**Re: 07ITBBELLROADPHASE-1  
R002 Bell Road Reuse Water Main Extension Phase 1**

**Addendum No. 3**

BELL ROAD REUSE WATER  
EXTENSION - PHASE I

12" PIPE CROSSING AT STATION 52+42

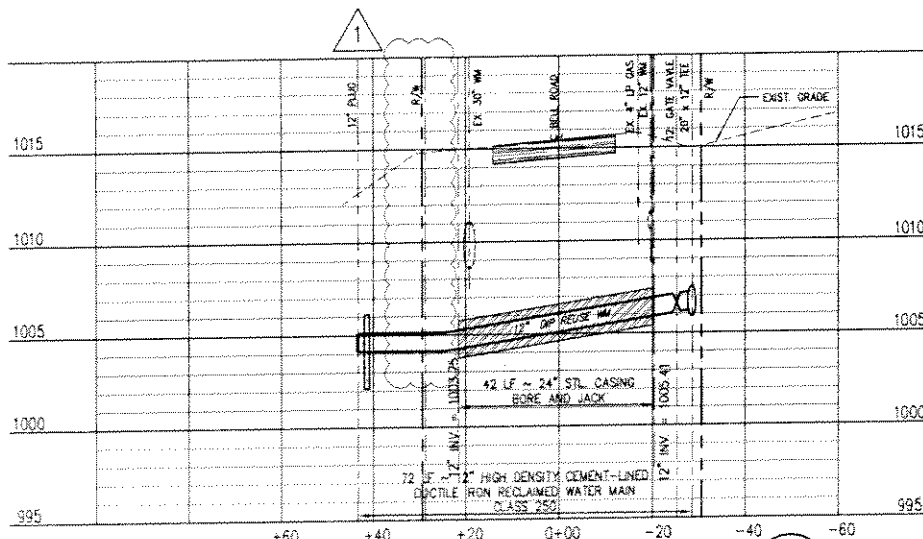
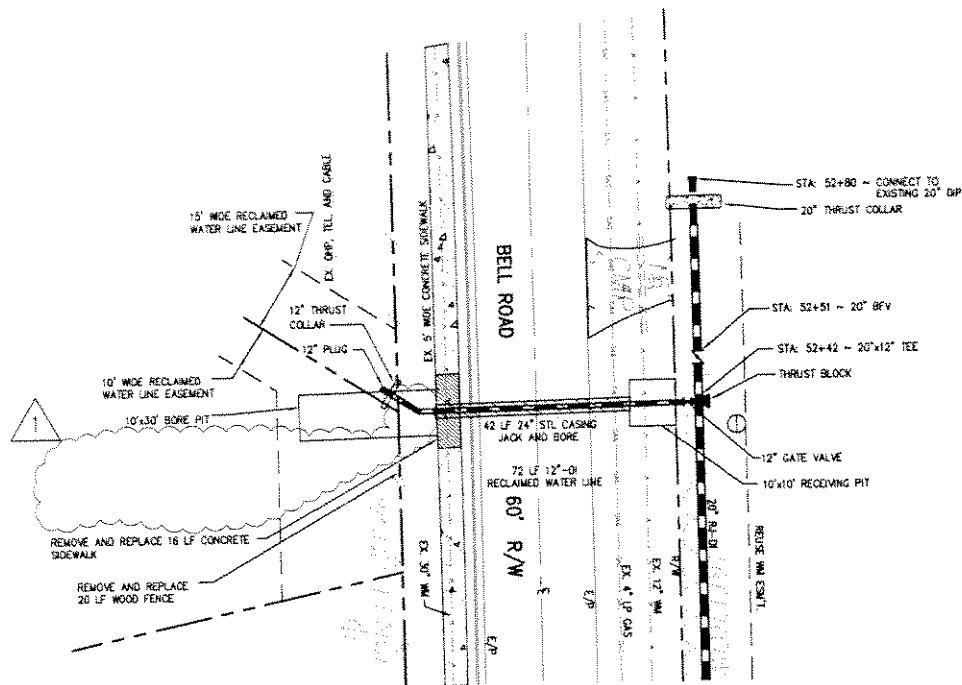
Sheet CD-04, modify 12" PIPE CROSSING AT STATION 52+42 DETAIL 4 per the attached sketch CD-04-1.

1. On sheet CD-04, there is a 12" meter with BFP shown. Is there a detail for this and can a bid item be added as this does not pertain to pipe excavation.

6. Is the 12" main inside the casing shown on sheet CD-04 required to be restrained joint pipe? If so, could a pay item be added?

Answer – See Addendum No. 3 Corrections.

Answer – No, bid as shown.
